SUBJECT: TECHNICAL EVALUATION REPORT FOR DRAFT WASTE DETERMINATION
FOR SALT WASTE DISPOSAL

TECHNICAL EVALUATION REPORT FOR

THE U.S. DEPARTMENT OF ENERGY SAVANNAH RIVER SITE

DRAFT SECTION 3116 WASTE DETERMINATION FOR

Figure 5 Engineered Closure Cap Side View

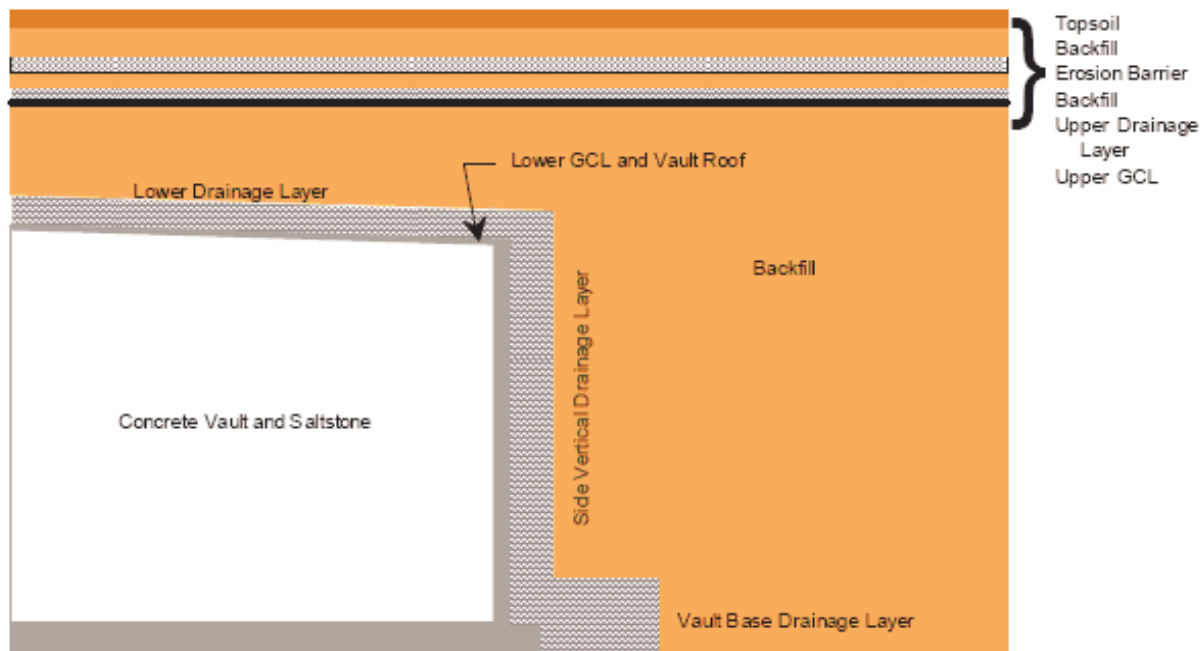
NRC staff requested that DOE provide its estimate of the amount of infiltration available to the wasteform that may be diverted due to the low permeability vault and saltstone. This type of information would provide an indication of how much credit was being taken by DOE for long-term cap performance. DOE provided a figure of fractional flow through the saltstone as a function of time for the base case PA (WSRC, 2005a). The fractional flow reaches a maximum of approximately 2×10^{-4} at 10,000 years. It is not clear how effective the lower drainage layer of the engineered cap would be at limiting infiltration to the waste at higher infiltration rates through the cap or for larger amounts of degradation to the saltstone and vaults

An independent NRC analysis suggests that the model used by DOE to estimate the effects of colloidal clay plugging the lower drainage layer may not be conservative. If the hydraulic properties of the lower drainage unit are modified uniformly throughout the layer to reflect partial plugging by colloidal clay, open-fracture flow may be allowed in less than a third of the time predicted by the DOE model, in which complete plugging occurs in a discrete sublayer within the lower drainage unit. The NRC staff expects that colloidal clay transport will result in the highest degree of clay deposition occurring at the top of the lower drainage layer, with clay deposition that may be smeared from the sharp front implied by the DOE model. The NRC staff recognizes that the rates of colloidal clay transport used by DOE are based on literature values (Phifer and Nelson, 2003), while the soils at the SRS have low pH values that may modify colloidal transport. Because the integrity of the lower drainage layer behavior affects every fracture, uncertainty in drainage layer behavior is expected to be important to performance. Uncertainty in the estimated rate of degradation of the lower drainage layer could be reduced through further studies or could be mitigated through additional conservatism in cap design.

Figure 6 Engineered Closure Cap Layers

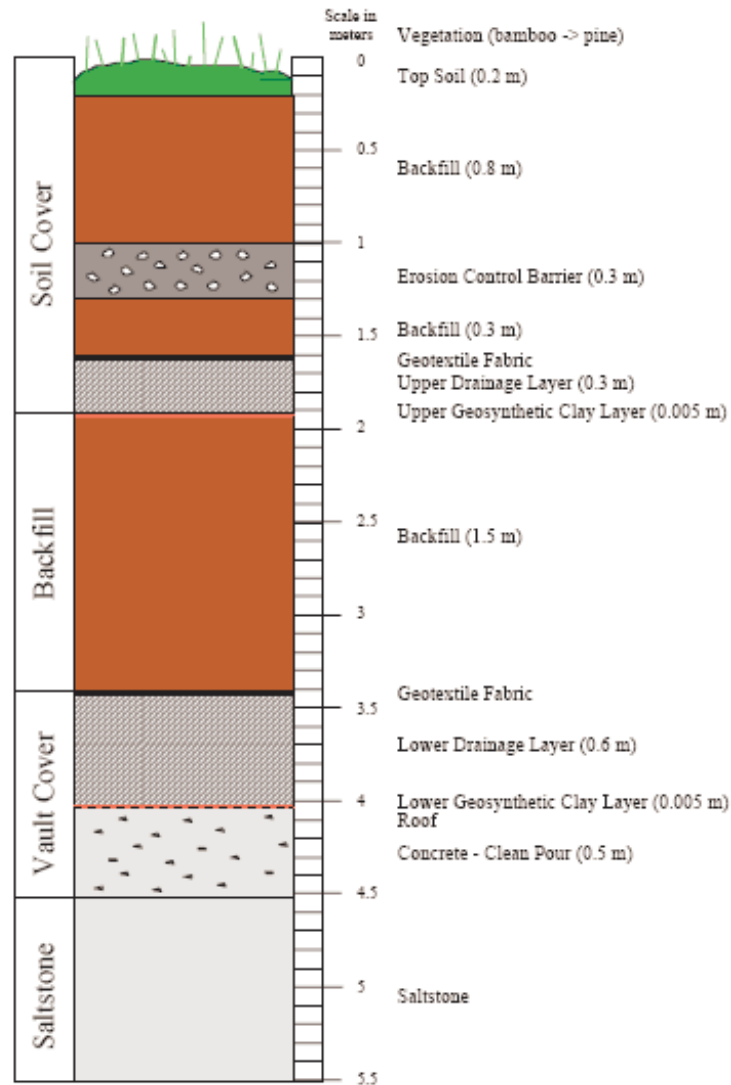
Staff reviewed the DOE calculations for stability of the top slope, side slopes, and apron. Based on review of the calculations, the conservatism associated with the design discharge, and the ability of the cover to provide adequate protection against the computed velocities and shear stresses, the staff concludes that the top slope should be stable under extreme flooding conditions. The proposed rock size for the side slope is adequate, and the apron design is acceptable (based on the conservatism associated with the computation of flow rates). Based on the acceptability of using procedures suggested in NUREG-1623, the riprap design should achieve the objectives. In addition, the proposed information and procedures are sufficient to ensure acceptable placement of the riprap and fill into the riprap voids.

Based on review of the information submitted by DOE and on independent calculations, the NRC staff concludes that DOE has provided sufficient information to conclude that the erosion protection design is adequate to provide reasonable assurance of long-term stability of the closure cap for erosion control purposes. It should be emphasized that DOE has provided a conceptual design, and this design could change in the future, depending on the number and location of vaults. Staff's conclusions on this conceptual design is based largely on the conservatism associated with the design, as proposed. There may be several individual design parameters which may not be acceptable if some of the other conservative design parameters are changed or removed. When making design changes, DOE should ensure appropriate conservatism is maintained.

Figure 7 Comparison of PORFLOW and Slag Lysimeter Data

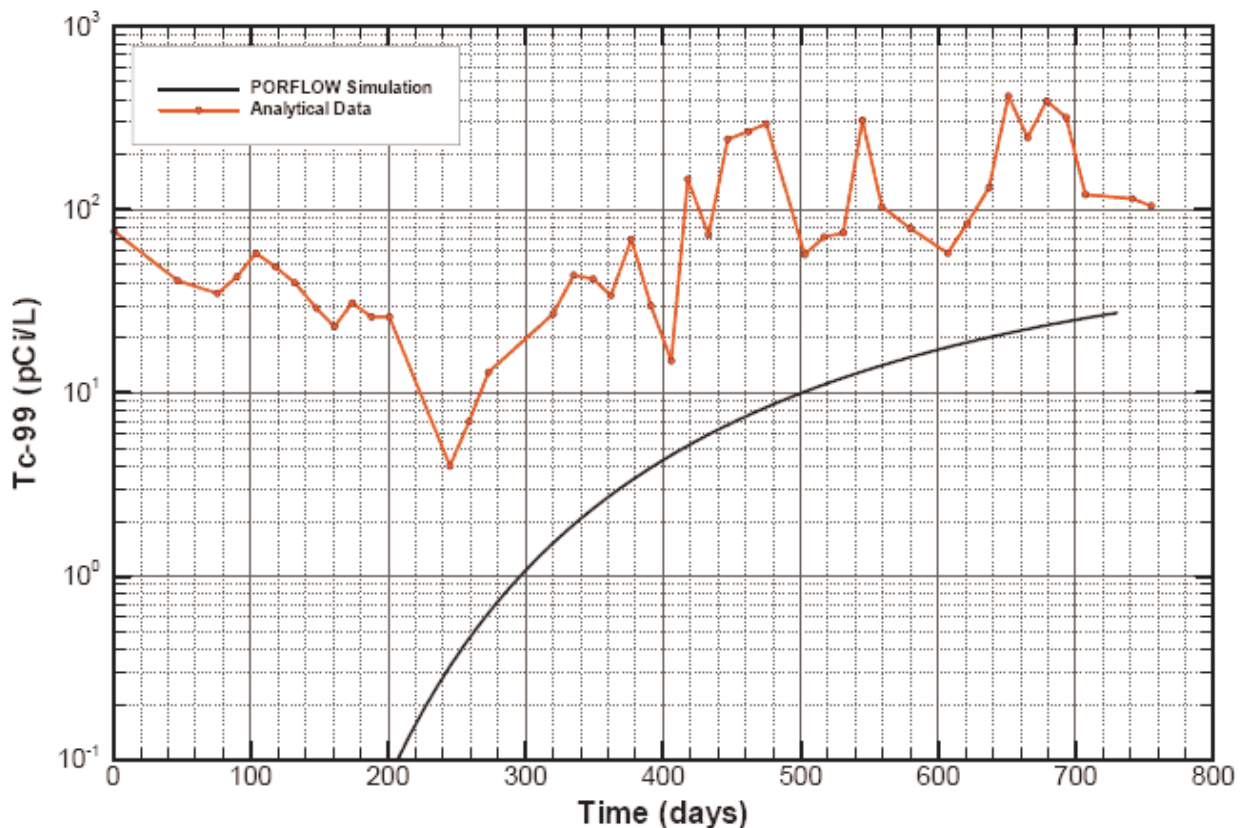
Model support is essential for deterministic modeling that is not clearly conservative because uncertainties are not represented in a deterministic analysis. Model support is information that provides confidence that the numerical model results are adequately representing the behavior of the actual system. Model support is commonly called model validation in the technical literature, but NRC recognizes that some aspects of PA are not amenable to scientific model validation (e.g., the long time frames) (NRC, 2000b). Model or software verification is a process to ensure that the numerical calculations are correct, but it does not ensure that the model results are appropriate for the given application. It does appear that DOE has performed adequate software verification for the main products it used to complete the PA (e.g., PORFLOW, HELP, internally developed intruder analysis software). NRC requested additional model support for key areas of DOE's PA in the RAI (NRC, 2005a). DOE stated that the information provided in (WSRC, 2005b) encompasses all currently available field data providing model support for the simulation results. A path forward that outlined how DOE intended to develop adequate model support was discussed in the August 17, 2005, meeting; however, a path forward was not provided in the written response to the action items (WSRC, 2005a).

The following example is intended to illustrate the types of information that could be developed to provide adequate model support. One of the key elements of DOE's PA is the reduction of Tc-99 in the wasteform by the addition of slag. As previously discussed, the sensitivity analyses demonstrate quite clearly that the rate and extent of oxidation of the wasteform is a key factor in meeting the protection of the public performance objective. DOE has performed basic research to evaluate whether the slag would result in Tc-99 being contained in a reduced form, and installed field-scale saltstone lysimeter tests with and without slag (Cook and Fowler, 1992). The slag-based lysimeters showed a much lower release rate of Tc-99 compared to the lysimeters without slag. At the request of NRC, DOE provided a comparison of a PORFLOW simulation with analytical data, that showed an underprediction by the model of roughly a factor of 10 (WSRC, 2005a). Figure 7 provides the comparison of the PORFLOW and slag lysimeter data. DOE explained the underprediction was the result of the analytical measurements being performed for gross non-volatile beta-gamma emitters, and therefore the results show essentially background. However, the data shows an increasing trend starting around day 250 that is consistent with the PORFLOW simulation, therefore it is unclear that the analytical data represents background. In addition to providing information on field-scale release rates, the slag lysimeters may contain valuable information about the rate of oxidation of the saltstone. Currently, DOE's estimates for the amount of oxidation of the saltstone over 10,000 years are based primarily on numerical modeling results. It may be possible to exhume and characterize a saltstone lysimeter. The depth of the penetration of the oxidation front should be able to be estimated and it would provide excellent model support for a key element of DOE's PA.
